MIL-C-27505B (USAF)
AMENDMENT 2
20 Jul 83
SUPERSEDING
AMENDMENT 1
12 JULY 1973

CARTRIDGE, ENGINE STARTER MXU-4A/A

This amendment forms a part of Military Specification MIL-C-27505B (USAF) dated 15 June 1967, and is approved for use within the Department of the Air Force and is available for use by all Departments and Agencies of the Department of Defense.

FIGURE 1. INTERIOR DIMENSIONS OF CARTRIDGE BREECH

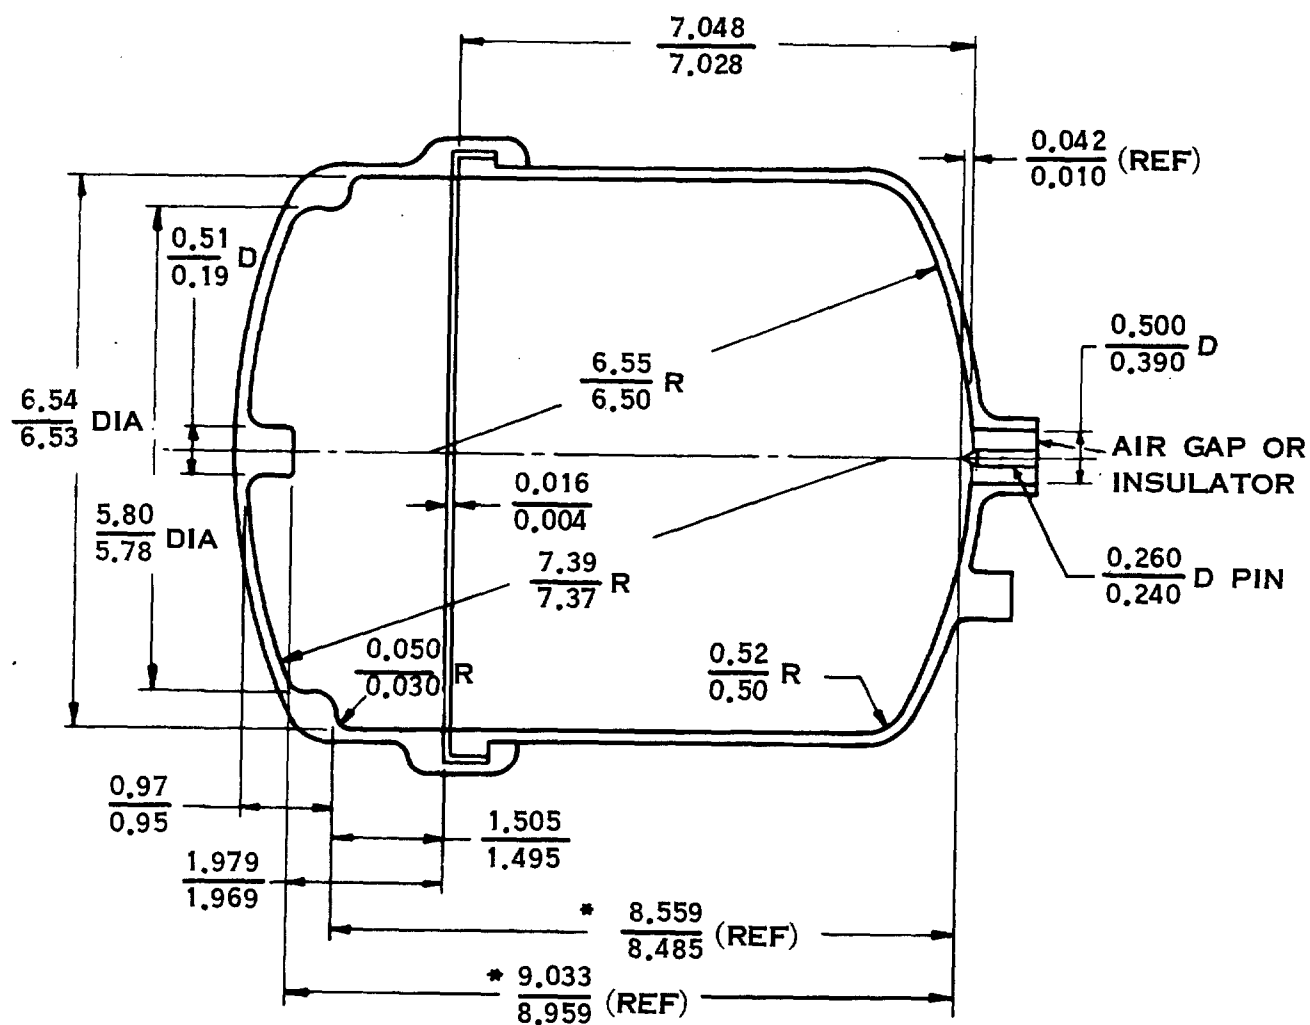
FIGURE 1: Delete and substitute the figure 1 attached hereto,

* EXTREME LIMITS OF TOLERANCE STACKUP
